NP-11-0028  
June 30, 2011

Subject: Exelon Nuclear Texas Holdings, LLC  
Victoria County Station Early Site Permit Application  
Response to Request for Additional Information Letter No. 07  
NRC Docket No. 52-042

Attached are responses to NRC staff questions included in Request for Additional Information (RAI) Letter No. 07, dated April 8, 2011, related to Early Site Permit Application (ESPA), Part 2, Sections 02.04.06, 02.05.02, and 11.02. NRC RAI Letter No. 07 contained twenty Questions. This submittal comprises a partial response to RAI Letter No. 07, and includes responses to the following two (2) Questions:

Figure 2.4.6-7 Source parameters for East Breaks slump - Bathymetry elevations are relative to MSL. (Source of bathymetry data: Reference 2.4.6-16)

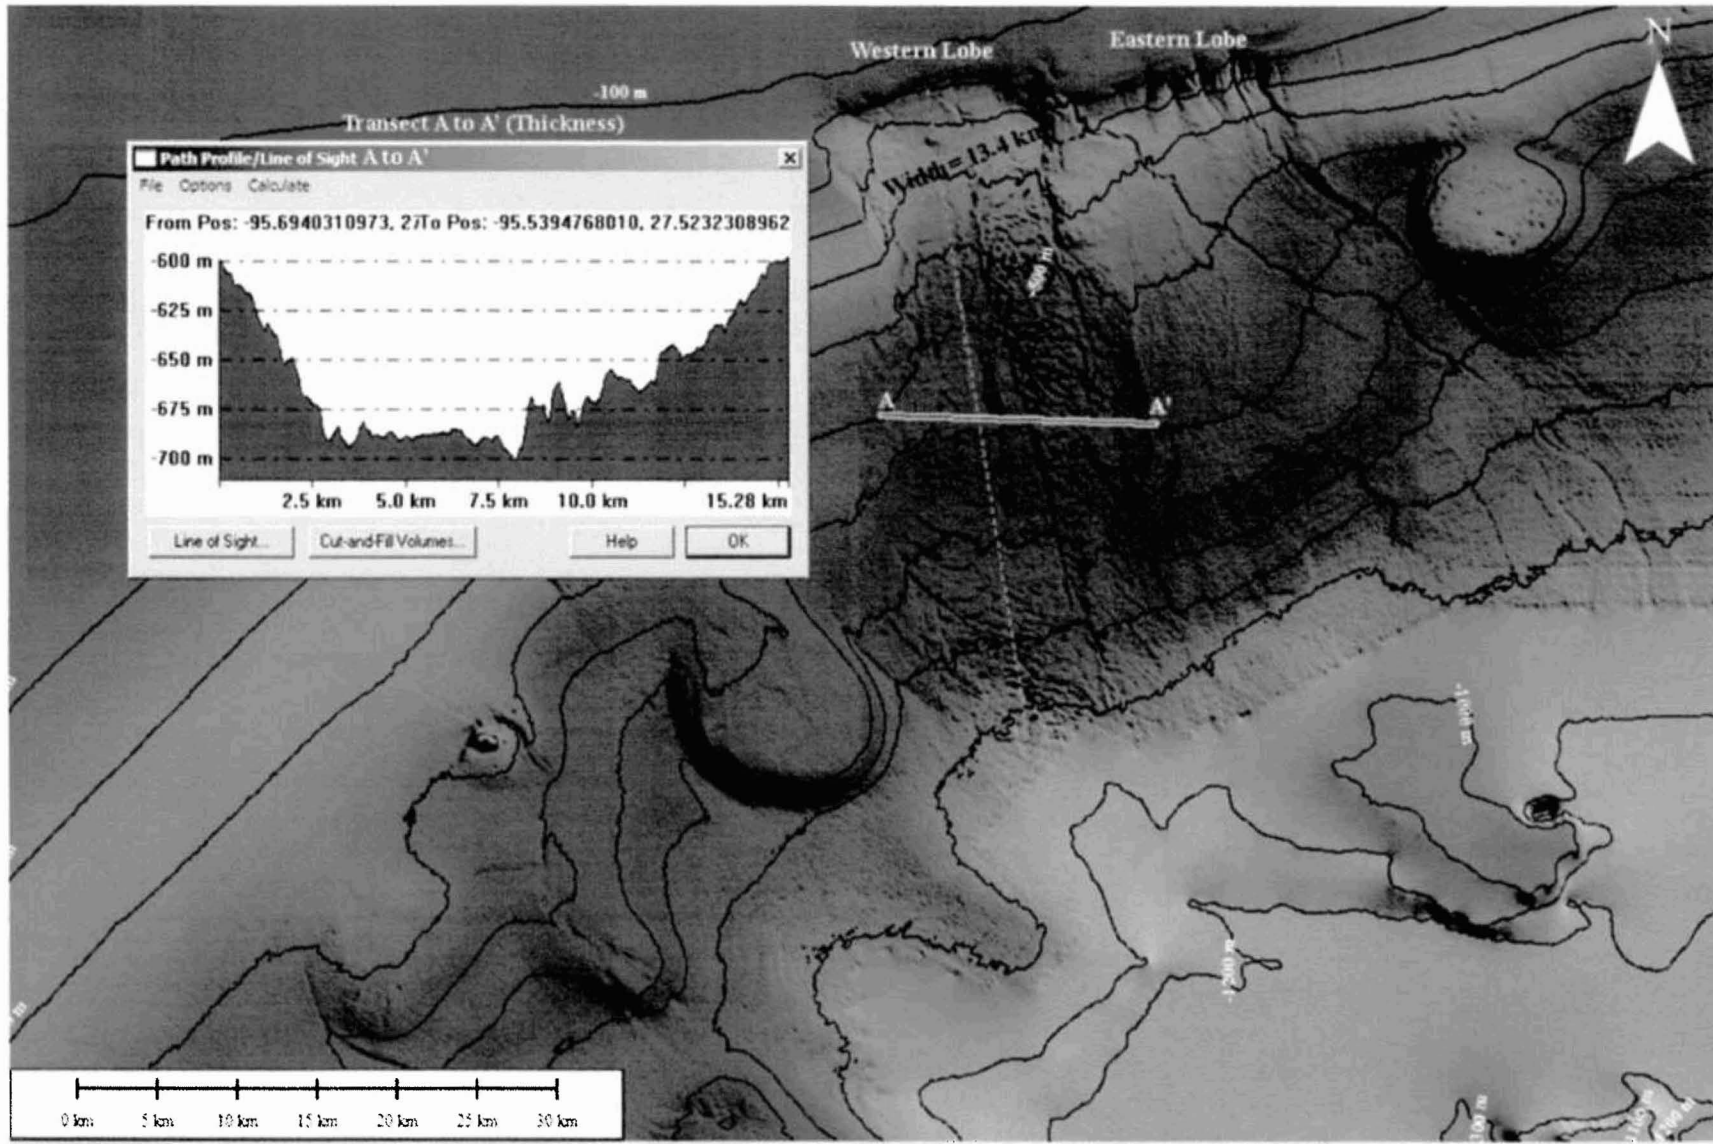
***Also provide the location, source volume and dimensions, and maximum displacement information for landslides in the Gulf of Mexico used for the analysis.***

With respect to wave generation, initial wave dimensions were estimated using the slump center of mass motion model, which is based on curve fits from sliding block experiments (Reference 12 and Reference 13). Source parameters for the East Breaks slump were discussed in the response to Item (6) of RAI 02.04.06-1 (Reference 1) (proposed SSAR Figure 2.4.6-7, attached) and are provided in the proposed text markup for SSAR Subsection 2.4.6.3.4.2. The specific gravity of the slump mass was assumed to be equal to 2 (Reference 12). The 100 m thickness (T) of the East Breaks slump with respect to the 600 m initial depth (d) ( $T/d=0.17$ ) and the slump thickness relative to the 42 km length (b) of the erosional chute ( $T/b=0.002$ ) suggests the initial wave height from the East Breaks slump would be relatively small. Using the NGDC bathymetry data (proposed SSAR Figure 2.4.6-7, attached) and the slump center of mass motion model from References 12 and 13, initial wave height for the East Breaks slump was estimated to be 7.9 m. Considering differences between investigators in interpreting landslide dimensions, the estimate of 7.9 m is similar to the “tsunami wave on the order of 7.6 meters” predicted by Trabant et al. (2001) [Reference 2.4.6-3].

Source parameters for the East Breaks slump were also estimated independently as part of hydrodynamic simulations performed for Reference 2.4.6-38. Source parameters were estimated from three-arc-second bathymetry data from the National Geophysical Data Center (NGDC) (Reference 2.4.6-16). Slump width was estimated to be approximately 13.4 km (Figure 2.4.6-7). The length of the erosional chute was estimated to be about 42 km. Based on a transect across the erosional chute, slump thickness was estimated to be about 100 m (see cross-section profile A to A' in Figure 2.4.6-7). With respect to slope, Reference 2.4.6-3 states that “initial failure of the slump took place on very low angle slopes of less than two degrees while present slump deposits have an average

Figure 2.4.6-8 Site location map showing VCS relative to STP 3 & 4, the East Breaks slump, and hypothetical buoy locations (VCS\_Buoy and STP\_Buoy) that were used for plotting time history for MOST model simulations. Bathymetry elevations are relative to MSL.

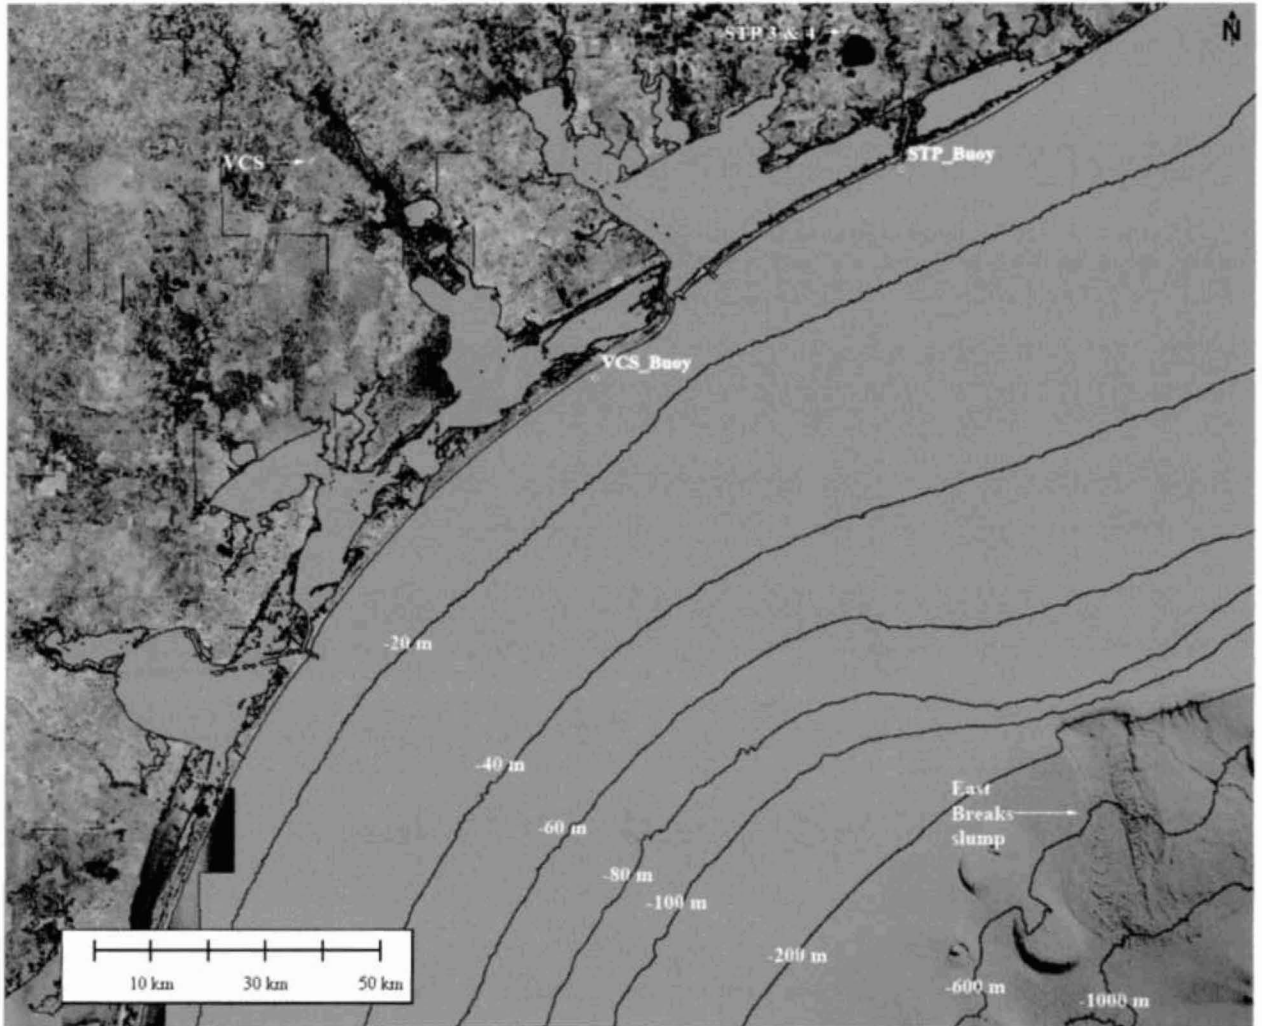
- (1) Choice of the East Breaks slide as the PMT source over other potential sources.

- (2) Propagation of the PMT from the source to the site, using bathymetric, coastline, and topographic information specific to the site.

As stated in Section 2.4.1.1 of the VCS Early Site Permit (ESP), VCS is located in Victoria County, Texas near the west bank of the Guadalupe River, at River Mile 29.6 (proposed SSAR Figure 2.4.6-8, attached). VCS is approximately 13 miles south of the

The largest SMF in the Salt province is the East Breaks slump. The East Breaks slump is located about 113 km (70 mi) from the South Texas coast and about 171 km (106 mi) from the VCS site (Figure 2.4.6-8). The coordinates of the slump are approximately 27.57° N and 95.64° W. The slump is comprised of an eastern lobe and a western lobe. Reference 2.4.6-30 states that “the western and eastern lobes are thought to have formed by two different processes, and actually at two different, but relatively close, time periods. The western lobe was formed by slump and debris deposits traveling downslope. The eastern lobe is more consistent with turbidity flow currents in the upper parts of the slide and leveed channels in the middle and lower portions of the slide.” Further, Reference 2.4.6-30 states that “the eastern lobe appears more channelized and consists of density flow-type fill with few large slump and intact blocks. The western lobe, therefore, carried the bulk of the failed material and the energy level of the failure was much greater.” As the eastern lobe was unlikely to have influenced tsunamigenesis, only the western lobe was used for the present simulations.

Maximum drawdown was estimated at a buoy located at depth of 7.7 m and approximately 1 mi offshore of the South Texas coast (Figure 2.4.6-8). At this location, significant drawdown of the water surface below 0 ft MSL occurred for initial negative waves for the PV20 and hypothetical “Monster” scenarios. Maximum drawdown for the PV20 simulation case had a duration of approximately 13 minutes, with a peak negative wave elevation of approximately -1.5 m (-4.9 ft) (MSL). Maximum drawdown for the “Monster” simulation case had a duration of about 11 minutes, with a peak negative wave elevation of about -1 m (-3.3 ft) (MSL). Therefore, maximum drawdown levels are not expected to impact any safety-related facilities at VCS.
